# FCC Class II Permissive Change Request Letter

RE: FCC Permissive II Change Request for Company: Arize Corporation FCC ID: 2AWPP-ASH110

We are submitting an application for a class II permissive change to the FCC approval of the Company name: Arize Corporation, product description: Smart Hub (FCC ID: 2AWPP-ASH110, Original Grant Date: 10/20/2020). The transmitter module itself has not changed. Here are the changes:

Network port component

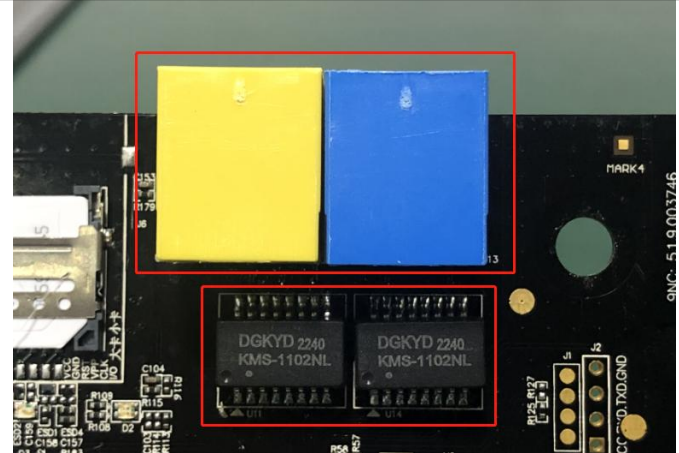
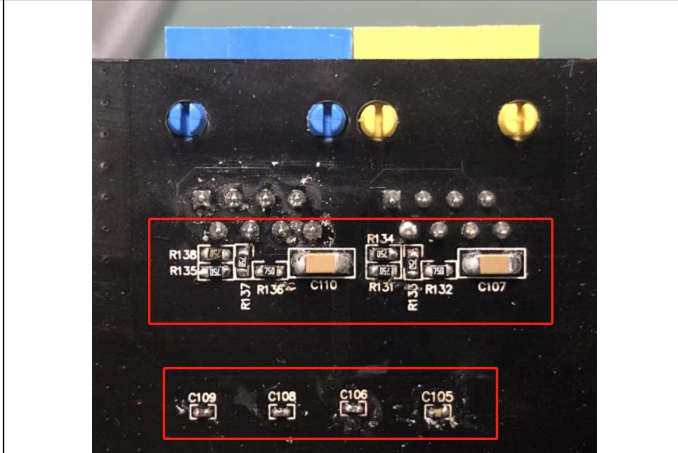
Add a network port assembly and peripheral resistor capacitor and a new adapter.

Network port IC, resistor and capacitor	New adapter
<p><b>IC:</b> U11, U14: KMS-1102NL</p> <p><b>Capacitor:</b> C105, C106, C108, C109: 0.1uF/10V C107, C110: 1nF/2KV</p> <p><b>Resistor:</b> R131, R132, R133, R134, R135, R136, R137, R138: 75R</p>
